INDESIT company

Model type:
UP1721HA

Commercial code:
F048479

07369-11 Exploded views

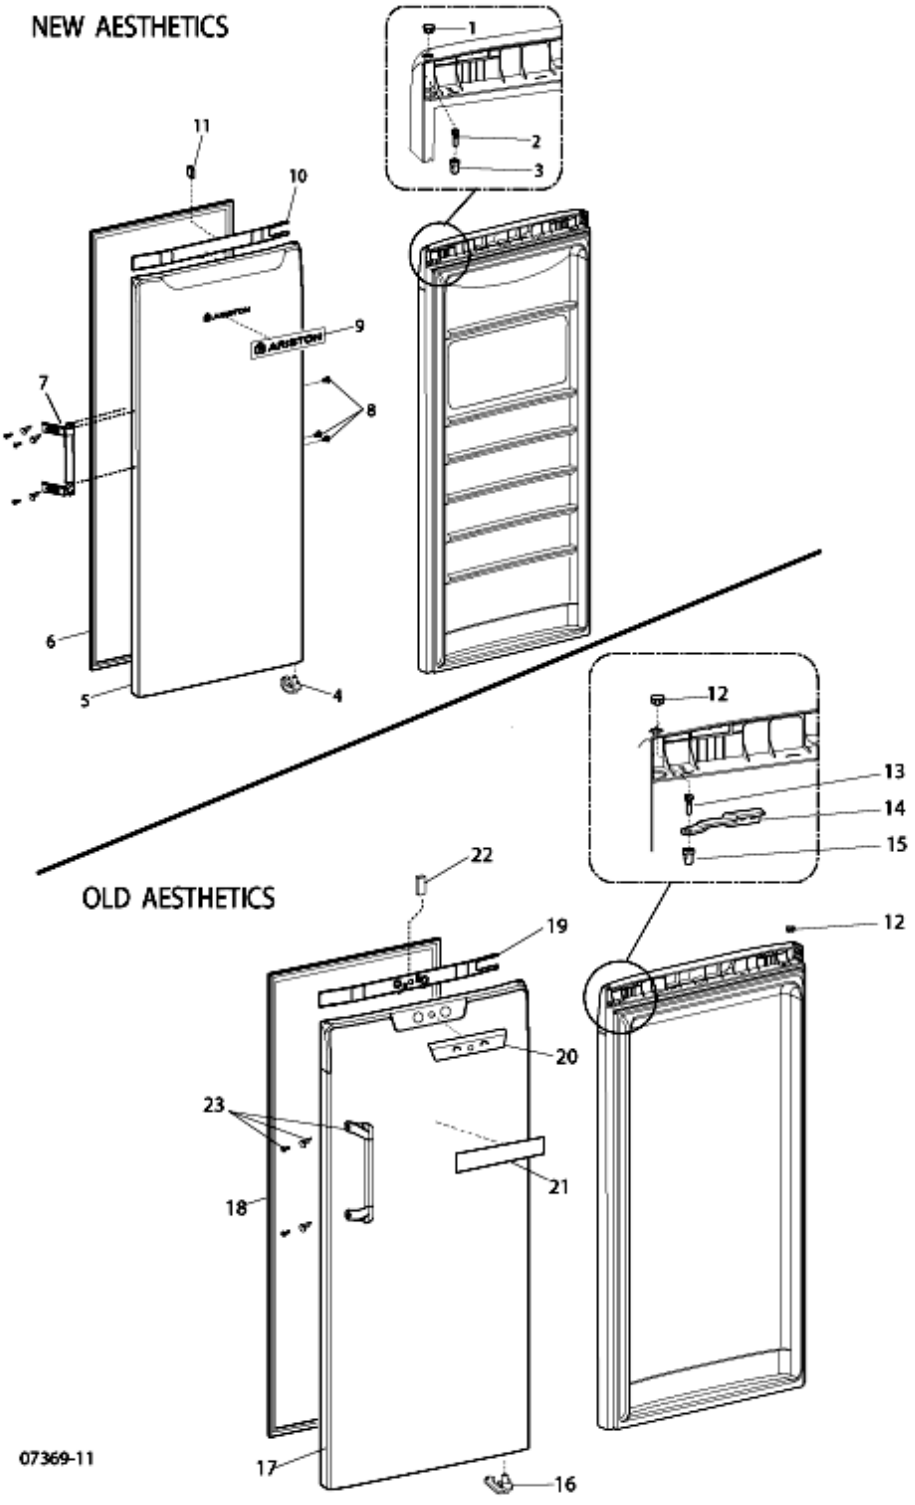
n3508g02: DOOR CHANGE - INTRO NEW GRAB HANDLE (3 SCREWS)

To Identify the correct parts refer to the Image in Partfinder and/or Service Net showing both the OLD & NEW Aesthetic Doors.
GRAB HANDLES -
MODELS with OLD Aesthetics - BEFORE SERIAL NUMBER COMMENCING 80712…. (12 July 2008) The grab handle used with this door has 2 screw fixings; 2 washers were introduced later (listed in the parts list). Where it is necessary to replace this type of grab handle, 2 screws and 2 washers should also be ordered and fitted. The handles for models FZ175P, FZ150P, RZ150P, UP1521, UP1511, UP1511F, UP1511FHA, UP1711FHA, UP1746HA, UP1711HA, UP1511HA(TK) are now available in a complete silver colour (Argento Vivo) rather than white with a silver bar. When stock of this Grab Handle becomes depleted a NEW Aesthetic DOOR & DOOR CONVERSION KIT will be required.
MODELS with OLD Aesthetics - AFTER SERIAL NUMBER COMMENCING 80713…. (13 July 2008) The grab handle used with this door has 3 screw fixings, compared to the original mentioned above, which has only 2. This handle is a seal break handle and is NOT inter-changeable with the previous handle or door

DOORS -
OLD Aesthetic DOORS are NO LONGER AVAILABLE for the above models. A NEW Aesthetic DOOR is available and is

inter-changeable with the OLD Aesthetic MODELS mentioned above. NOTE: A DOOR CONVERSION KIT C00273834 will be required if this door is to be fitted to an OLD Aesthetic model. The DOOR CONVERSION KIT consists of the following: 2x Hinge Pin Cover Grey (Argento), 2x Hinge Pin Cover Silver (Argento Vivo), 2x Hinge Pin Cover Stainless Steel (Inox), 1x Hinge Bush, 1x Cover Strip, 1x Grab Handle (3 Fix Grey & Silver), 3x Grab Handle screw, 3x Grab Handle washer, 1x Closure Aid (L/H), 1x Lower Hinge Pin, 1x Lower Hinge, 1x Upper Hinge screw, 1x Upper Hinge, 1x Lower Hinge Fixing Plate. The logo/badge is not included. Therefore, when requesting a replacement door for this appliance you should also request a new logo/badge.
3 fixing hole type GRAB HANDLE SHOULD NOT BE USED ON DOORS/MODELS PRODUCED BEFORE serial number 80712…., UNLESS IT HAS THE NEW Aesthetic DOOR ALREADY FITTED.
DISCLAIMER: The part supplied may differ from the original in colour, form or content, but is considered to be an acceptable interchangeable alternative. In accordance with its policy of progressive product design and environmental protection, Indesit Company reserves the right to alter specifications and use quality recycled components.

n3508a03: IDENTIFYING COMPS & SPECIFIC PARTS IN PARTS LIST

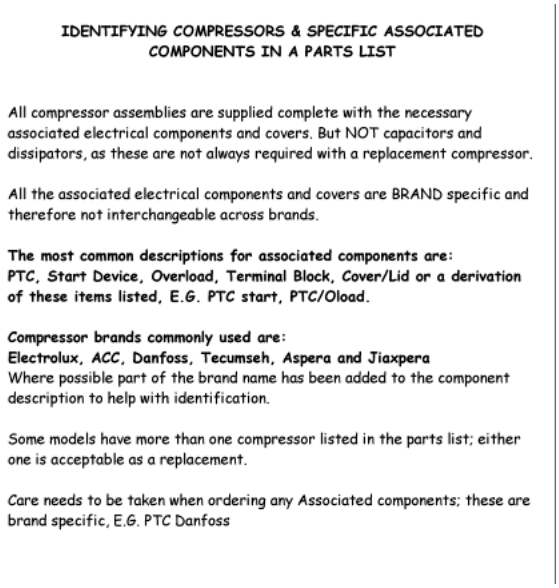
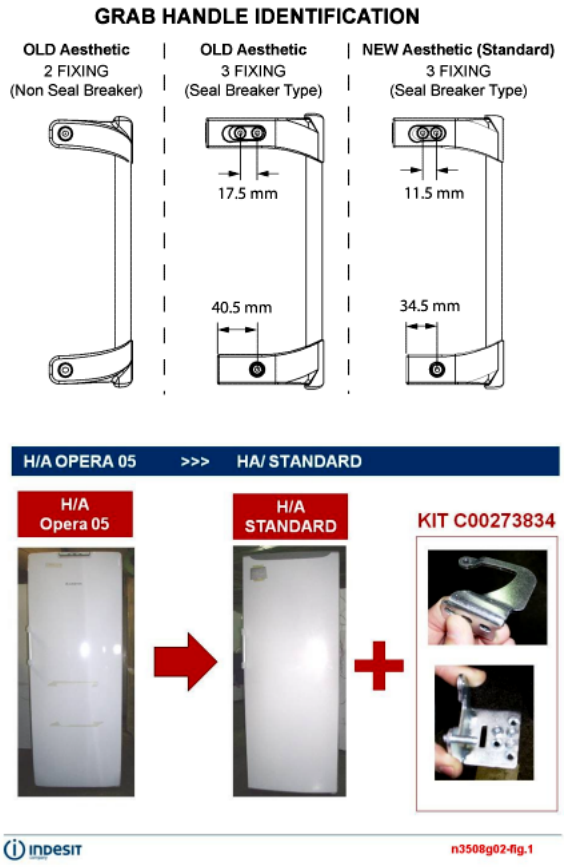
IDENTIFYING COMPRESSORS & SPECIFIC ASSOCIATED COMPONENTS IN A PARTS LIST

All compressor assemblies are supplied complete with the necessary associated electrical components and covers. But NOT capacitors and dissipators, as these are not always required with a replacement compressor.

All the associated electrical components and covers are BRAND specific and therefore not interchangeable across brands.

The most common descriptions for associated components are:
PTC, Start Device, Overload, Terminal Block, Cover/Lid or a derivation of these items listed, E.G. PTC start, PTC/Oload.

Compressor brands commonly used are:
Electrolux, ACC, Danfoss, Tecumseh, Aspera and Jiaxpera
Where possible part of the brand name has been added to the component description to help with identification.

Some models have more than one compressor listed in the parts list; either one is acceptable as a replacement.

Care needs to be taken when ordering any Associated components; these are brand specific, E.G. PTC Danfoss
